C

Response to community submissions

Figure C4-1 Indicative spoil haulage route for Darley Road civil and tunnel site (C4)

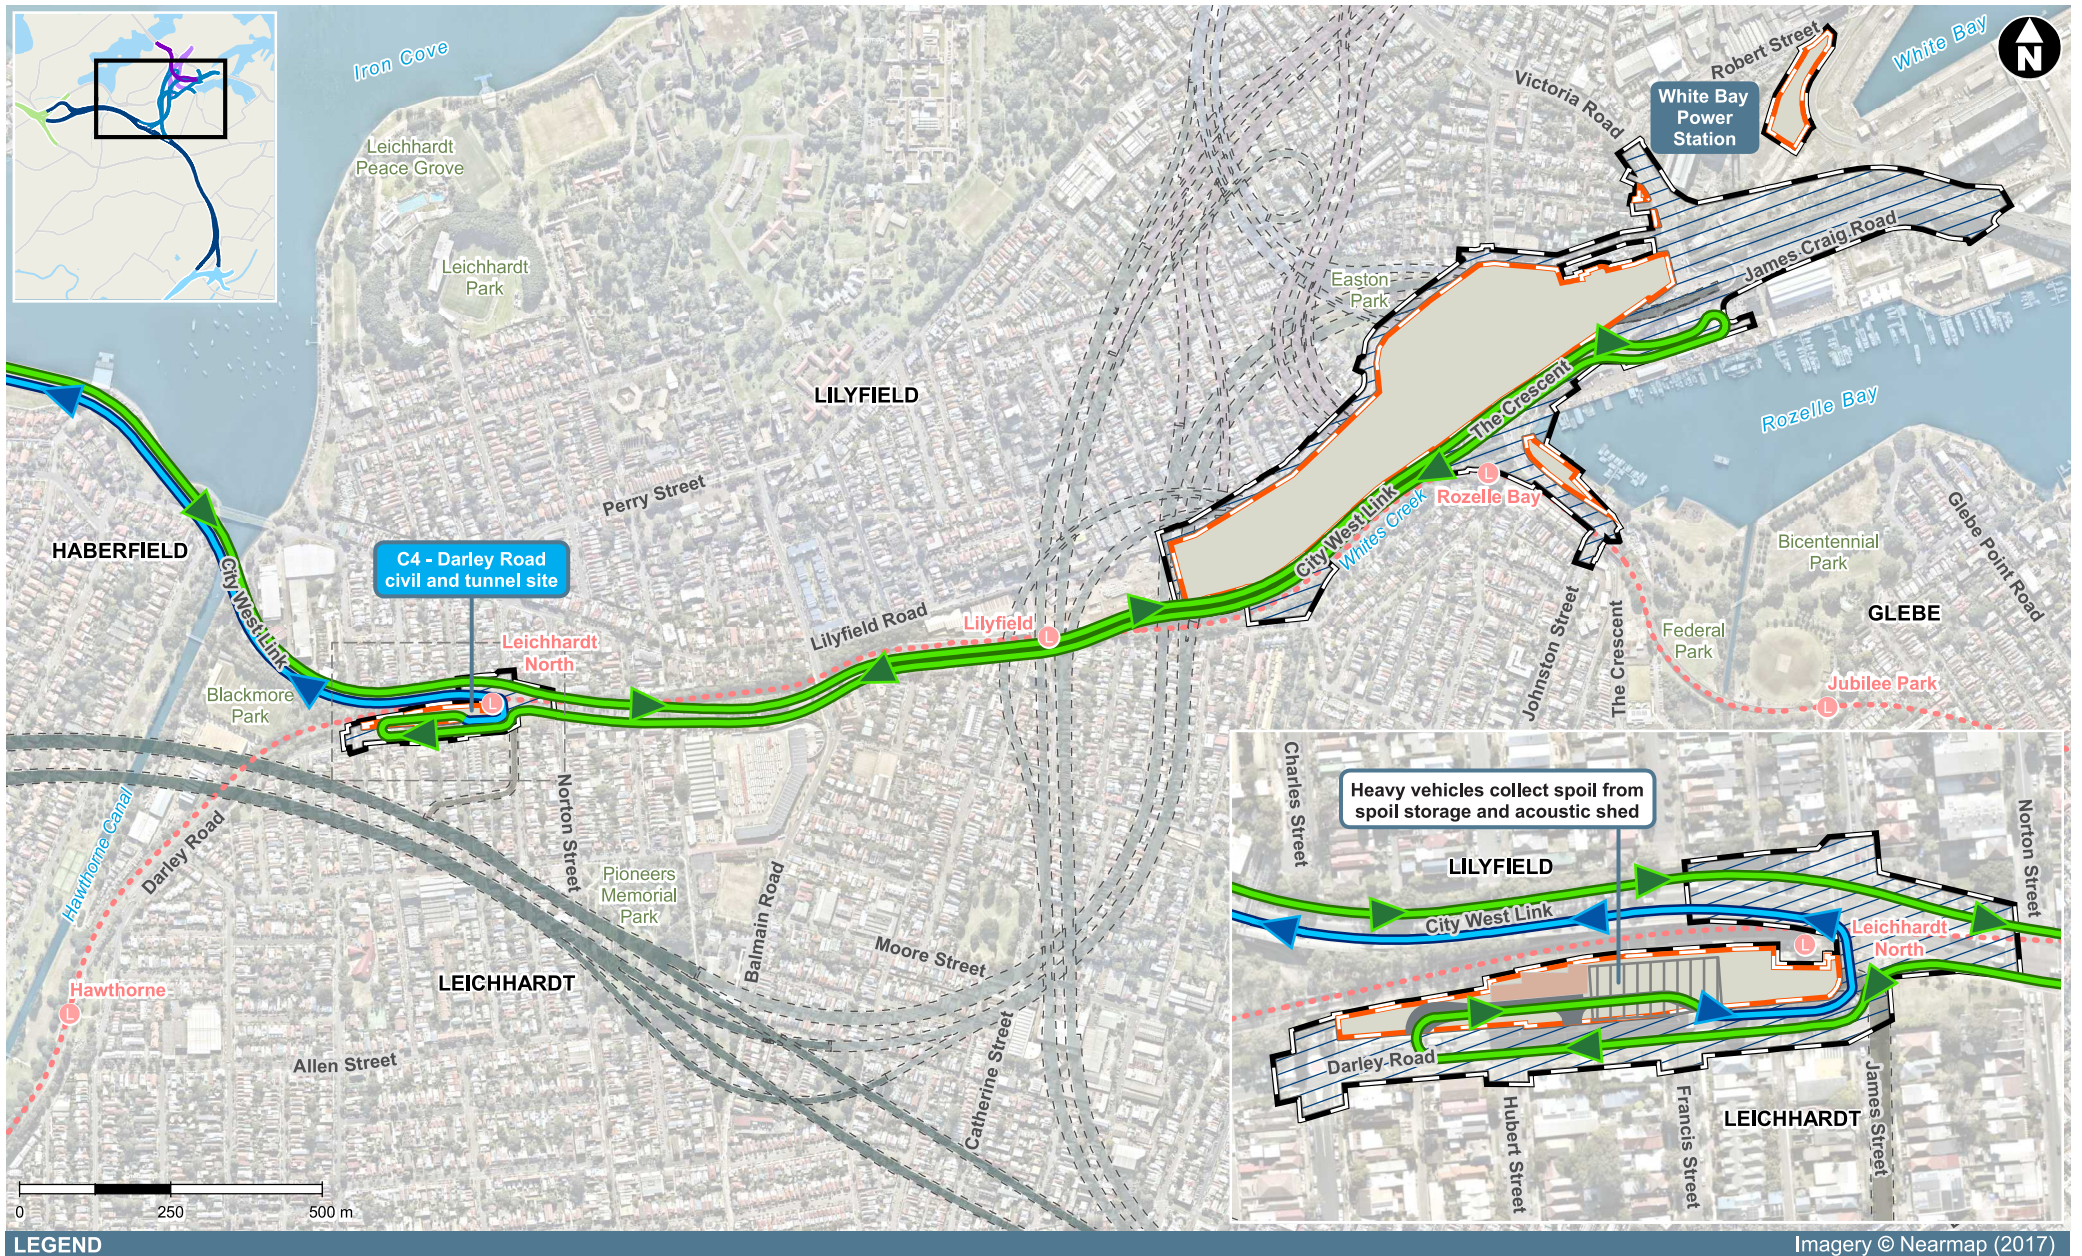
- The use of Darley Road by construction traffic (in particular trucks) and associated impacts, including:
 - Impacts on the performance of the road network, including City West Link/James Street/Darley Road intersection
 - Safety impacts on other motorists and pedestrians
 - Changes to access, including *Disability Discrimination Act 1992* (Commonwealth) (DDA) compliant access, to nearby amenities including the Leichhardt North light rail stop
- Noise impacts on nearby receivers from construction traffic and construction activities occurring within the site.

Refinement of the design of the Darley Road civil and tunnel site (C4) has been undertaken in response to the concerns outlined above and would involve:

The design changes would provide opportunities to reduce potential traffic and noise impacts while minimising physical changes to the EIS design. The indicative new construction haulage route is shown in **Figure C4-1**.
